WATTS BAR NUCLEAR PLANT (WBN) - RTD BYPASS LOOP ELIMINATION/UTILIZATION OF
EAGLE 21 ELECTRONICS - FSAR CHAPTER 15

Enclosed are marked-up pages to the WBN FSAR Chapter 15 reflecting the elimination of the RTD bypass loop and the utilization of Eagle 21 system electronics. According to the schedule, it is requested that NRC review these proposed changes and forward questions to TVA the week of February 23, 1987. The enclosed changes, along with any other changes resulting from your review, will be incorporated into a subsequent FSAR amendment.

Figure 15.2-4. Pressurizer Pressure Transient and Nuclear Power Transient for Uncontrolled Rod Withdrawal from Full Power with Minimum Feedback and 80 PCM/SEC Withdrawal Rate

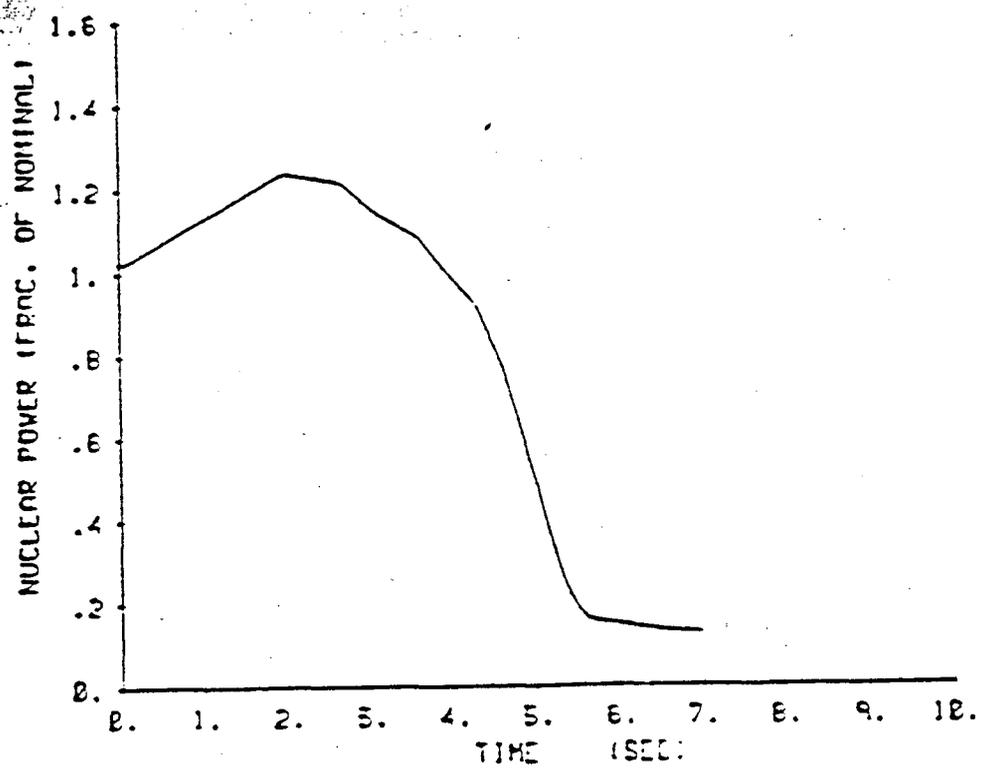
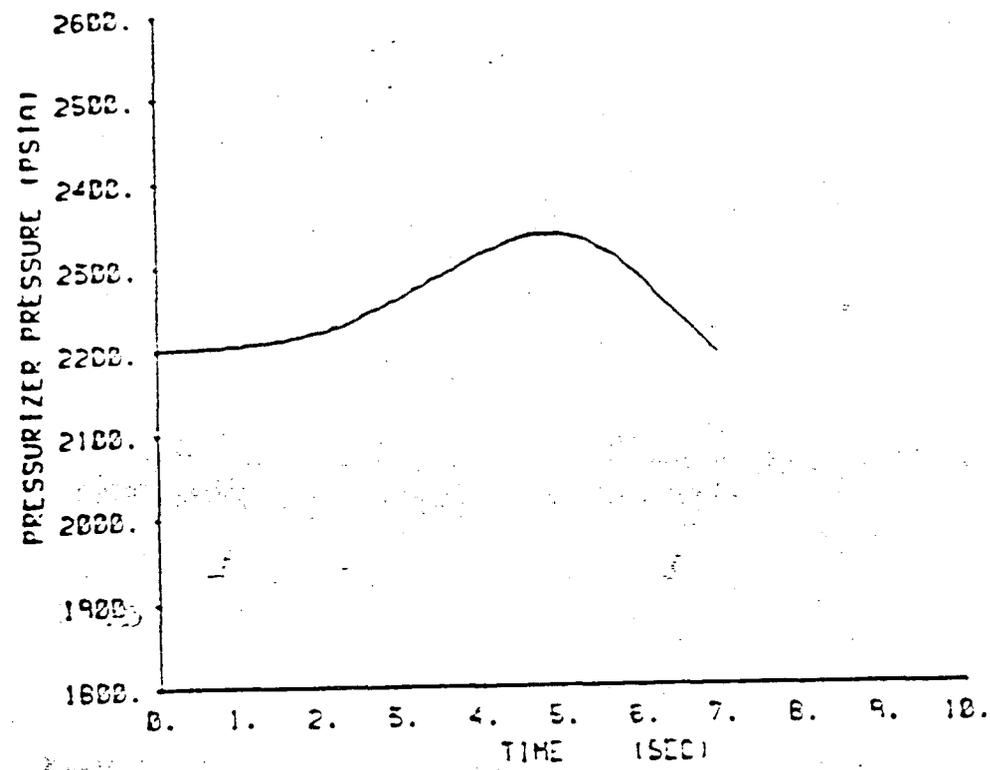
Figures 15.2-4 and 15.2-5 show the response of neutron flux, pressurizer pressure, average coolant temperature, and DNBR to a rapid RCCA

withdrawal incident starting from full power. Reactor trip on high neutron flux occurs shortly after the start of the accident. Since this is rapid with respect to the thermal time constants of the plant, small changes in T_{avg} and pressure result and a large margin to DNB is maintained.

Figure 15.2-6. Pressurizer Pressure Transient and Nuclear Power Transient for Uncontrolled Rod Withdrawal from Full Power with Minimum Feedback and 3 PCM/SEC Withdrawal Rate

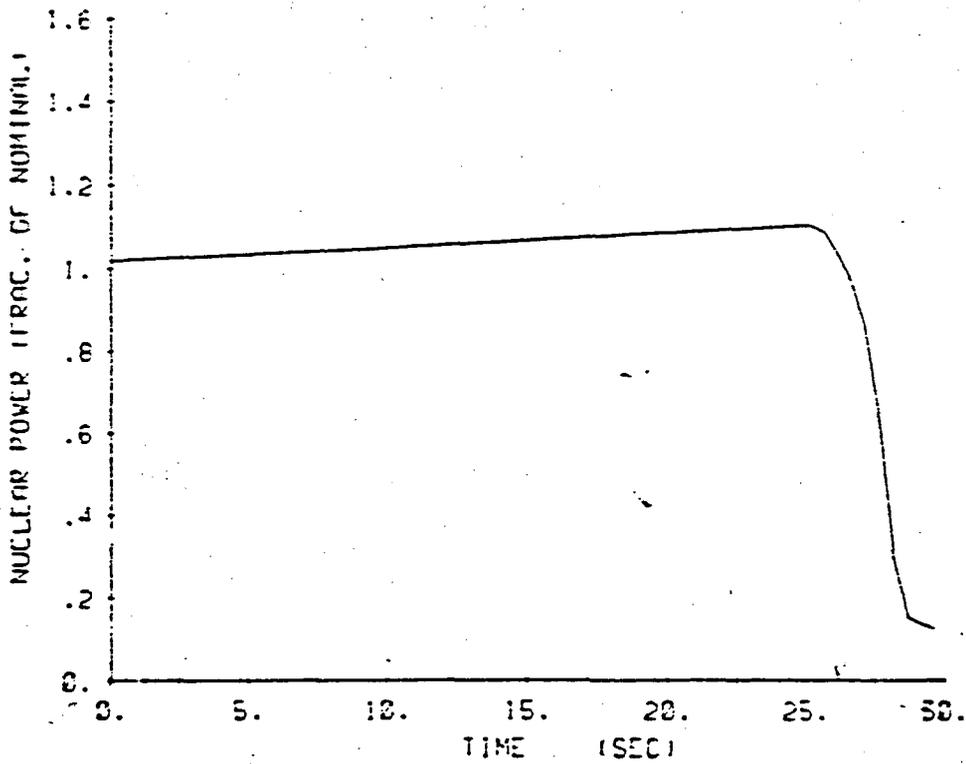
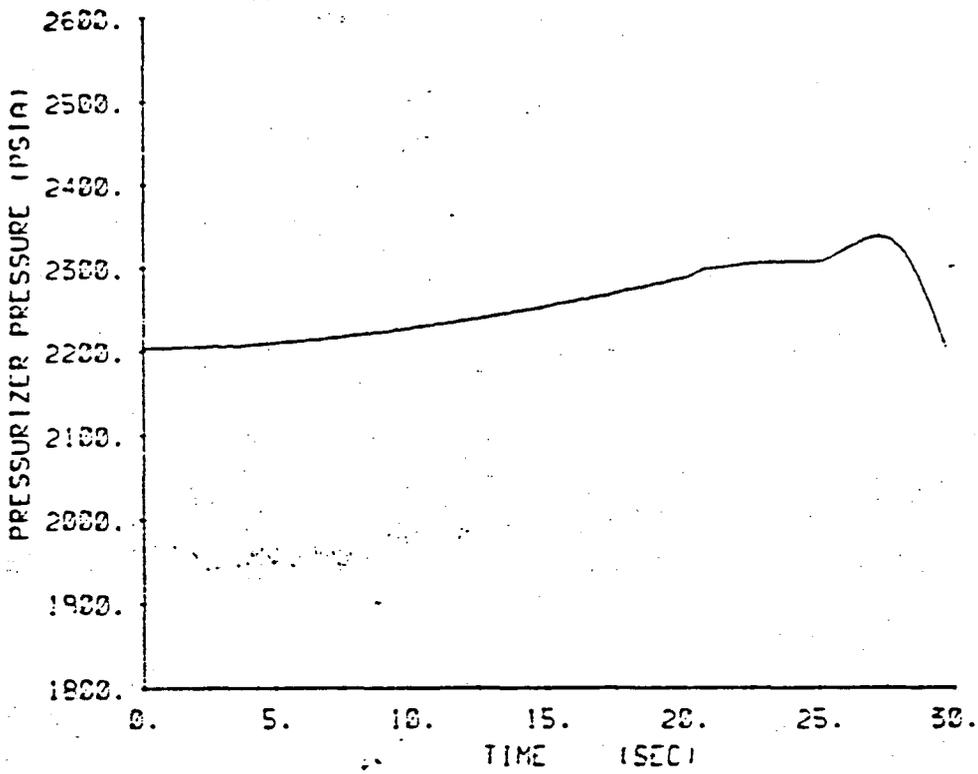
The response of neutron flux, pressure, average coolant temperature, and DNBR for a slow control rod assembly withdrawal from full power is shown in Figures 15.2-6 and 15.2-7. Reactor trip on overtemperature ΔT occurs after a longer period ~~and for the rise in temperature and pressure is consequently larger than~~ ^{of time} for ^{the} rapid RCCA withdrawal incident and the rise in temperature is consequently larger. 53

Figure 15.2.8. Effect of Reactivity Insertion Rate on Minimum DNBR for Rod Withdrawal Accident from 100% Power

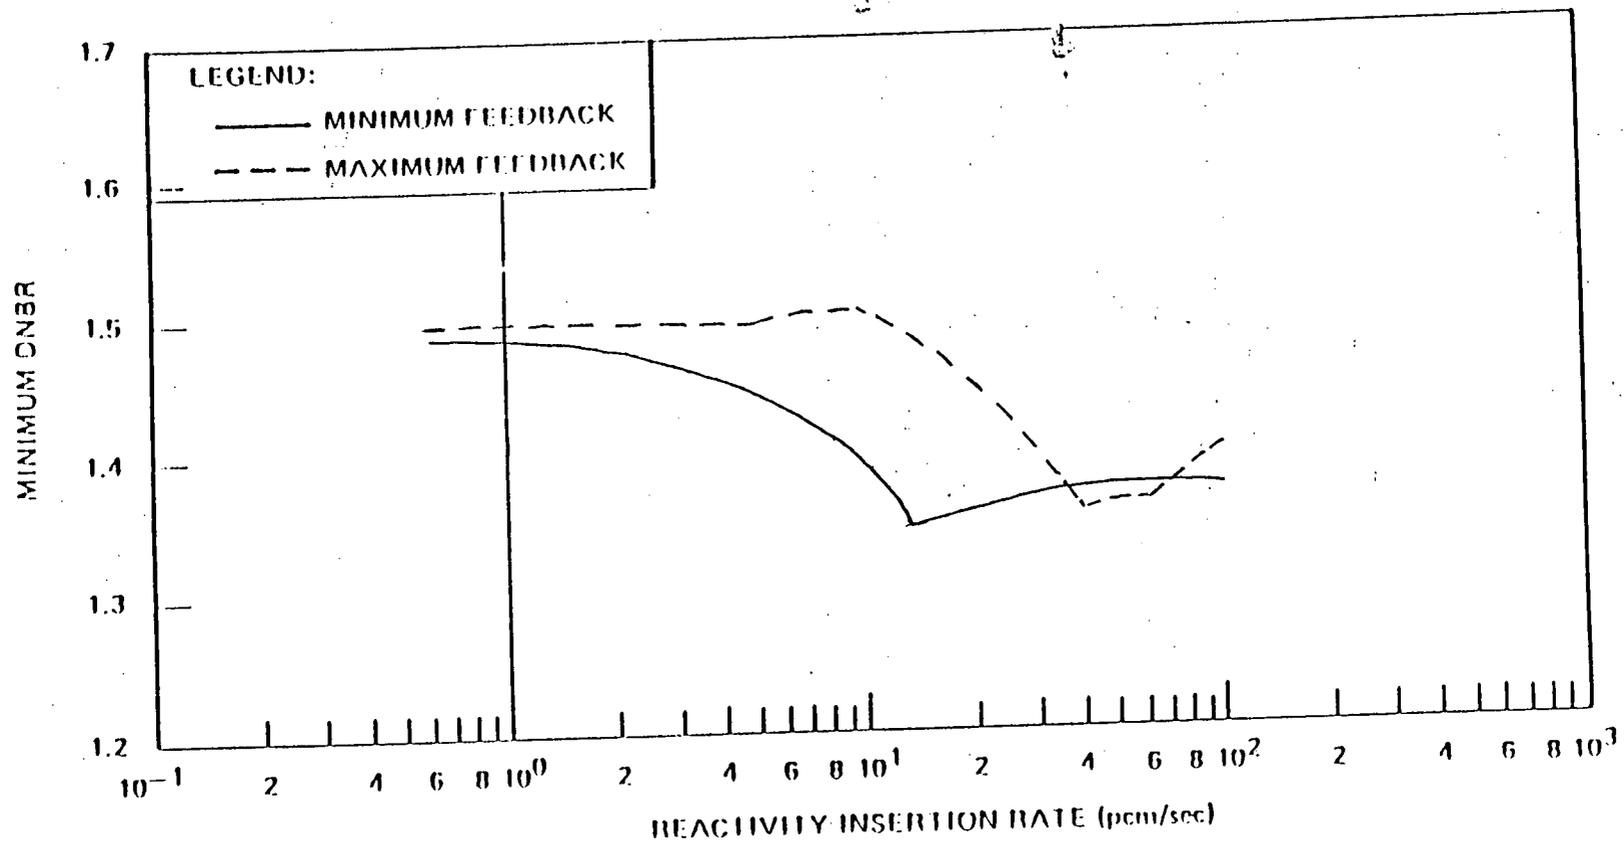
Figure 15.2-8 shows the minimum DNBR as a function of reactivity insertion rate from initial full power operation for the minimum and maximum reactivity feedback. It can be seen that two reactor trip channels provide protection over the whole range of reactivity insertion rates. These are the high neutron flux and overtemperature ΔT trip channels. The minimum DNBR is never less than 1.30. 53

For transients initiated from higher power levels (for example, see Figure 15.2-8) this effect, described in item 4 above, which results in the sharp peak in minimum DNB ratio at $\sim 5 \times 10^{-5} \delta k/\text{sec}$, does not occur since the steam generator safety valves are never actuated prior to trip.

Figure 15.2.9. Effect of Reactivity Insertion Rate on Minimum DNBR for Rod Withdrawal Accident from 60% Power

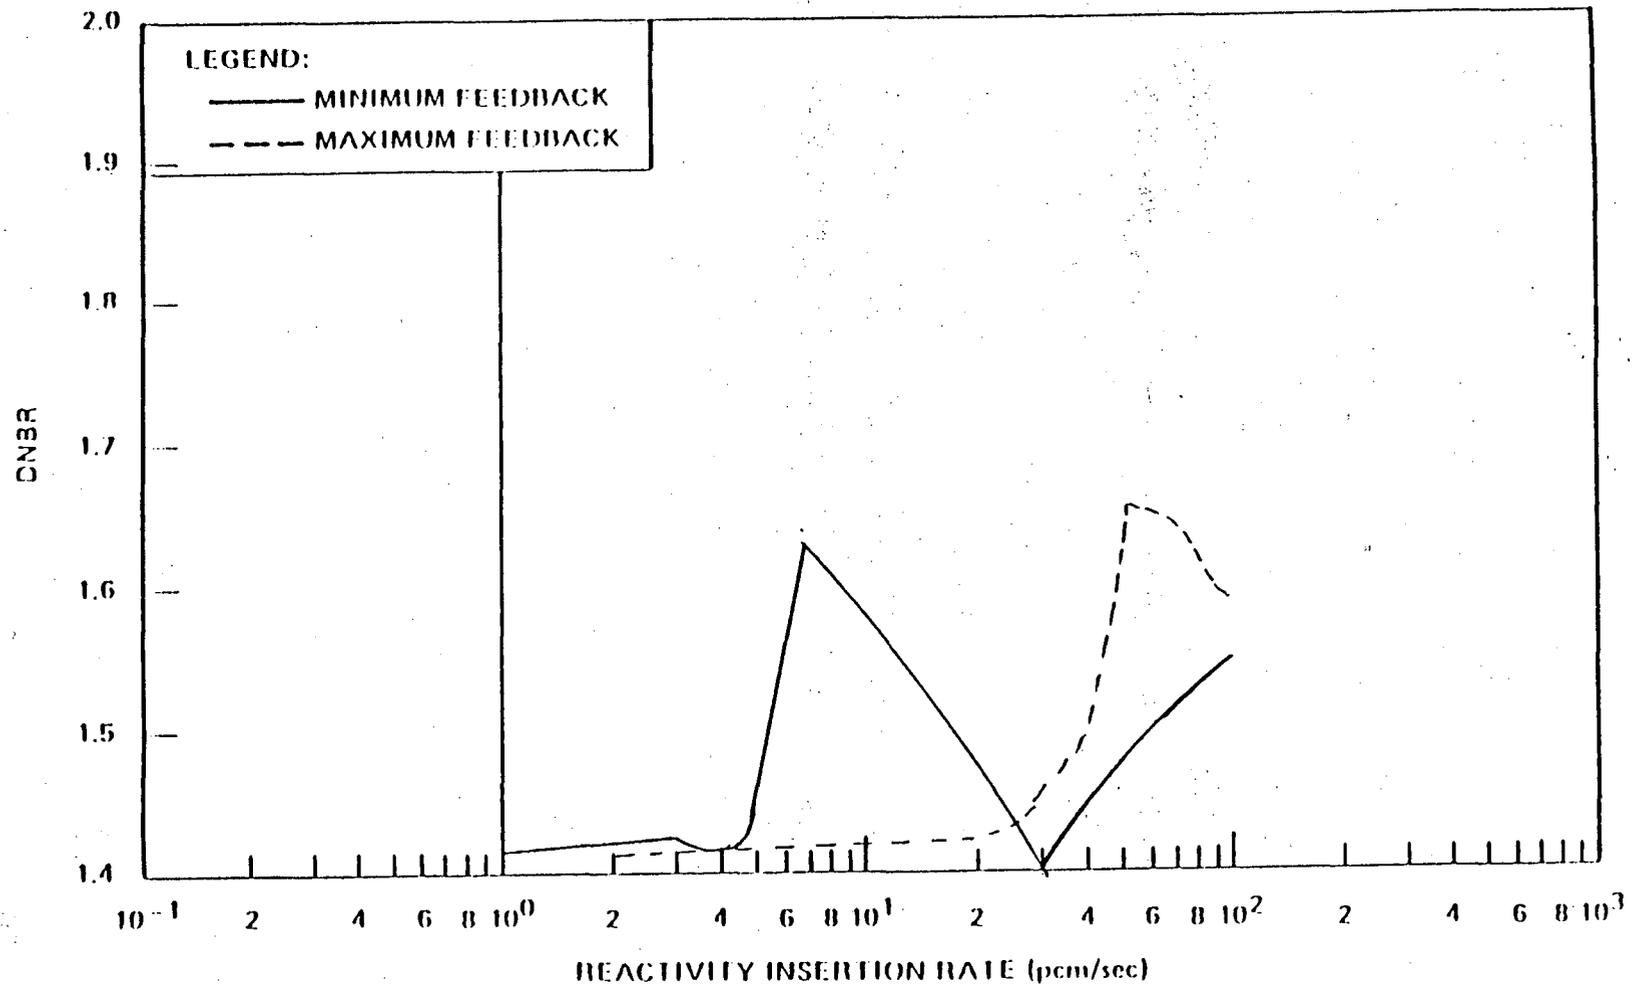
Figures 15.2-9 and 15.2-10 show the minimum DNBR as function of reactivity insertion rate for RCCA withdrawal incidents starting at 60 and 10 percent power respectively. The results are similar to the 100 percent power case, except as the initial power is decreased, the range over which the overtemperature ΔT trip is effective is increased. In neither case does the DNBR fall below 1.30. 53

Referring to Figure 15.2-9, for example, it is noted that

1. For high reactivity insertion rates (i.e. between $\frac{4.0}{2.0} \times 10^{-4}$ $\Delta k/k/sec$ and 8.0×10^{-4} $\Delta k/k/sec$) reactor trip is initiated by the high neutron flux trip. The neutron flux level in the core rises rapidly for these insertion rates while core heat 53

3. With further decrease in reactivity insertion rate, the overtemperature ΔT and high neutron flux trips become equally effective in terminating the transient (e.g., at $\sim \frac{4.0}{4.0} \times 10^{-4} \delta K/\text{sec}$ reactivity insertion rate).
 For reactivity insertion rates between $\sim \frac{4.0}{4.0} \times 10^{-4} \sim K/\text{sec}$ and $\sim 5 \times 10^{-5} \delta K/\text{sec}$ the effectiveness of the overtemperature ΔT trip increases (in terms of increased minimum DNB ratio) due to the fact that with lower insertion rates the power increase rate is slower, the rate of rise of average coolant temperature is slower and the system lags and delays become less significant.

Figure 15.2-20 Loss of Load Accident with Pressurizer Spray and Power-Operated Relief Valves, Beginning-of-Life

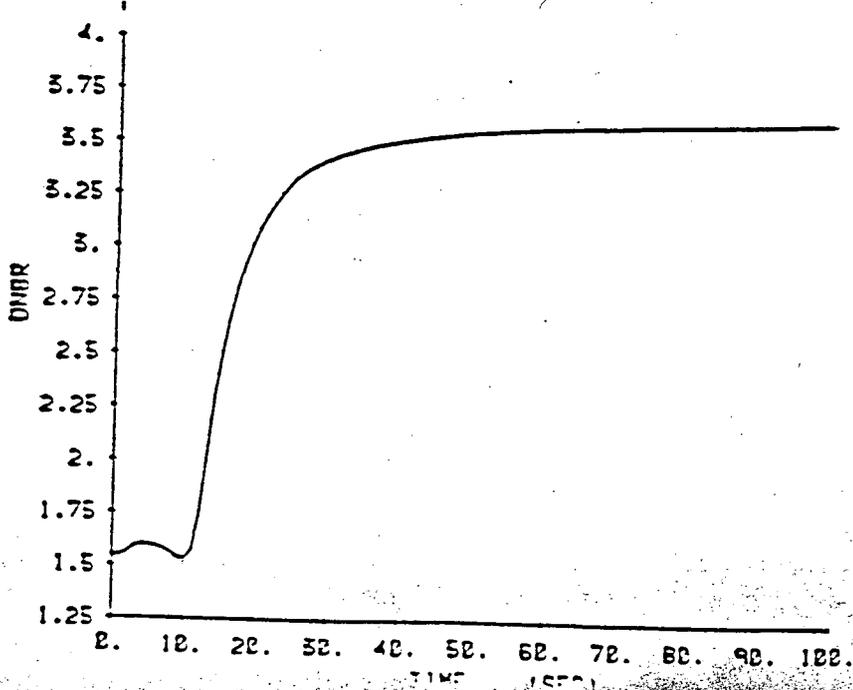
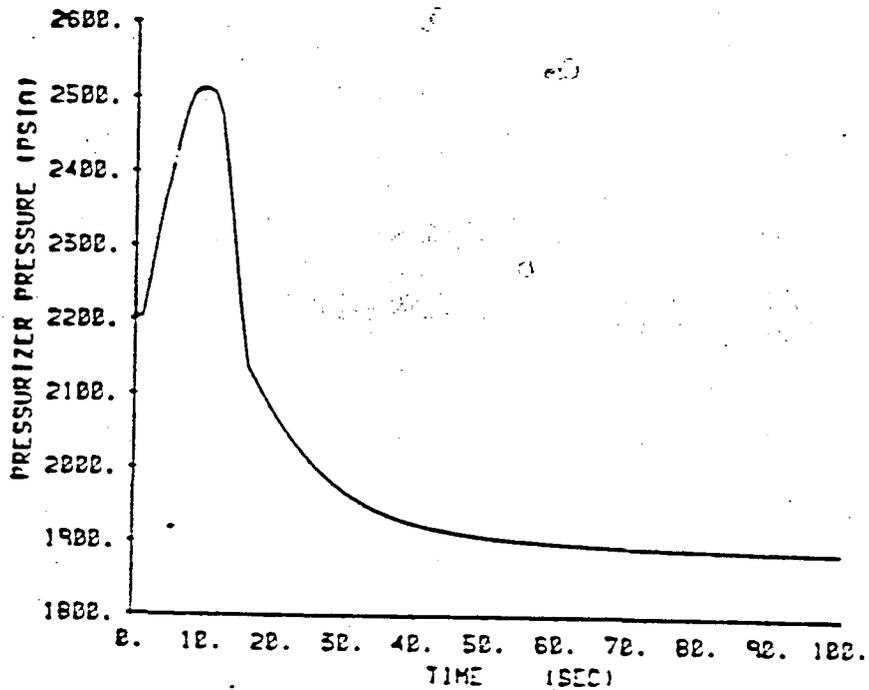
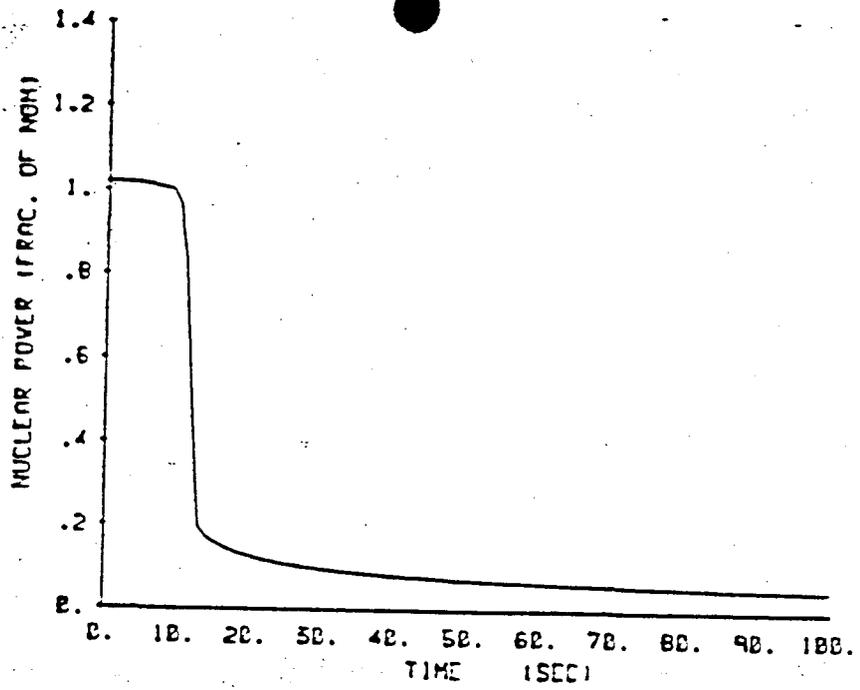
Figures 15.2-19 and 15.2-20 show the transient responses for the total loss of steam load at beginning-of-life with a least negative moderator temperature coefficient assuming full credit for the pressurizer spray and pressurizer power-operated relief valves. No credit is taken for the steam dump. The reactor is tripped by the ~~overtemperature AT trip channel~~. The minimum DNBR is well above the 1.30 value.

high pressurizer pressure signal

Figure 15.2-21 Loss of Load Accident with Pressurizer Spray and Power-Operated Relief Valves, End-of-Life

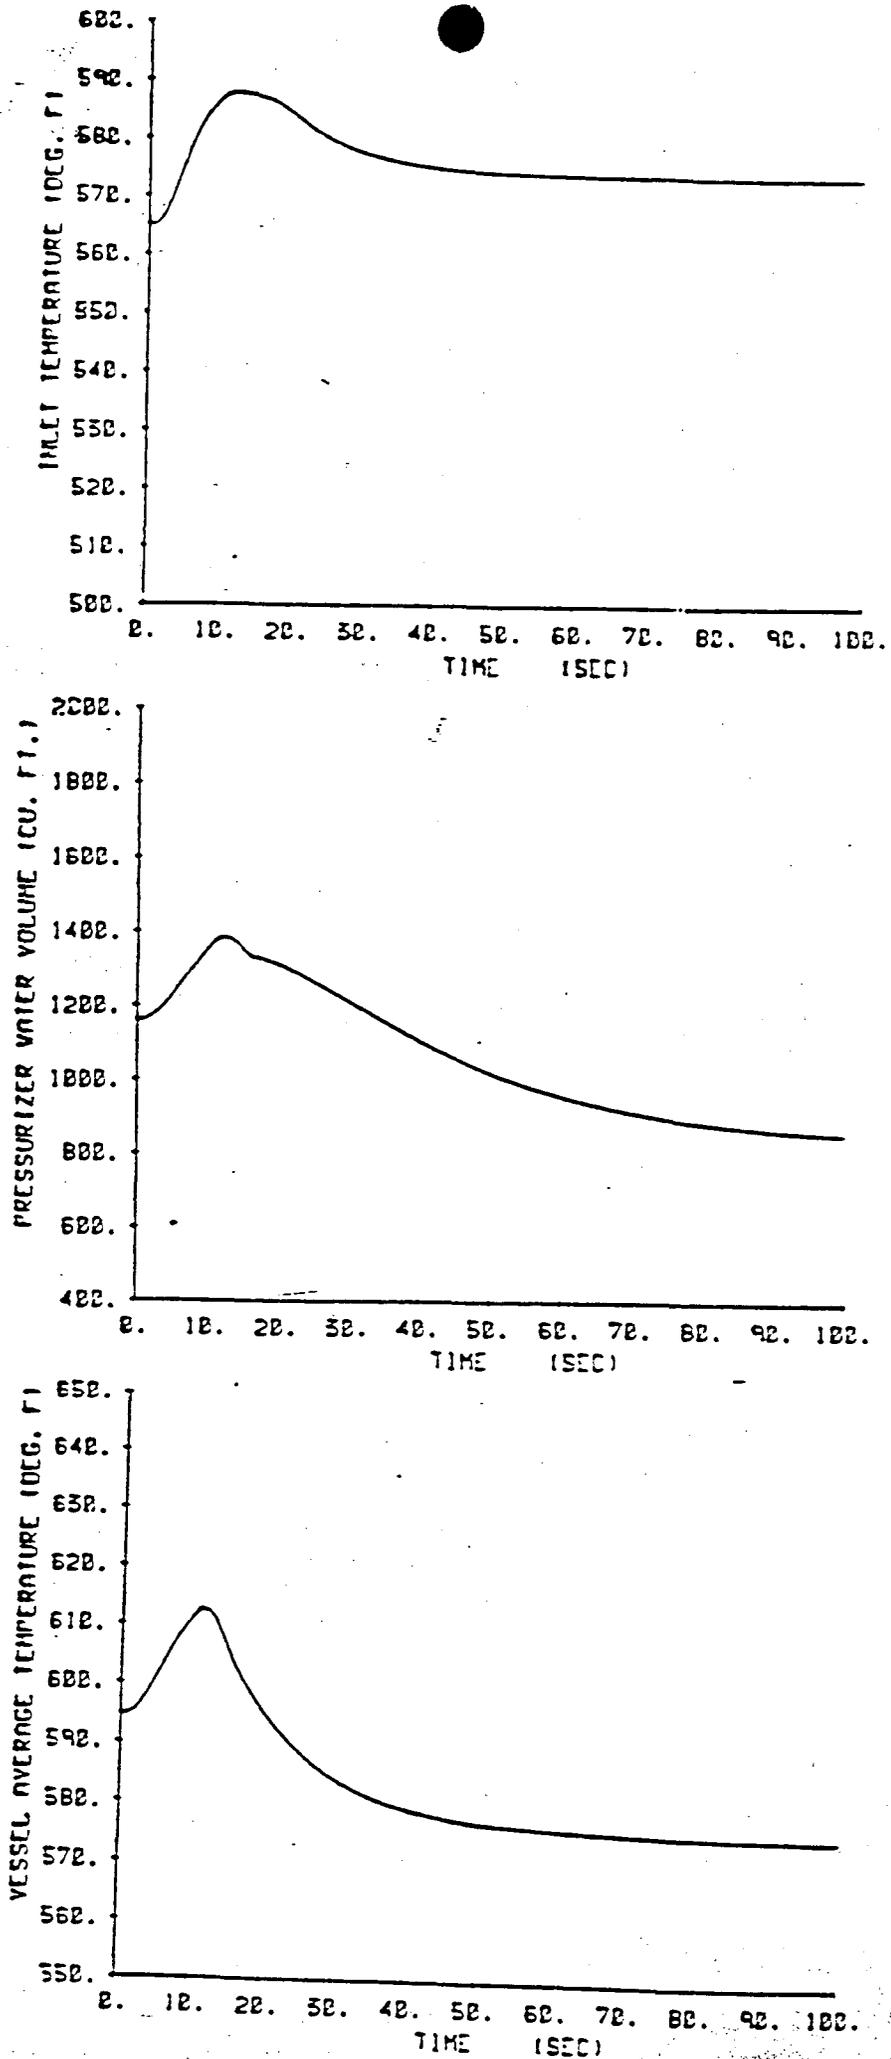
Figures 15.2-21 and 15.2-22 show the responses for the total loss of load at end-of-life assuming a large (absolute value) negative moderator temperature coefficient. All other plant parameters are the same as the above. The DNBR increases throughout the transient and never drops below its initial value. *The reactor is tripped by the low-low steam generator water level signal.*
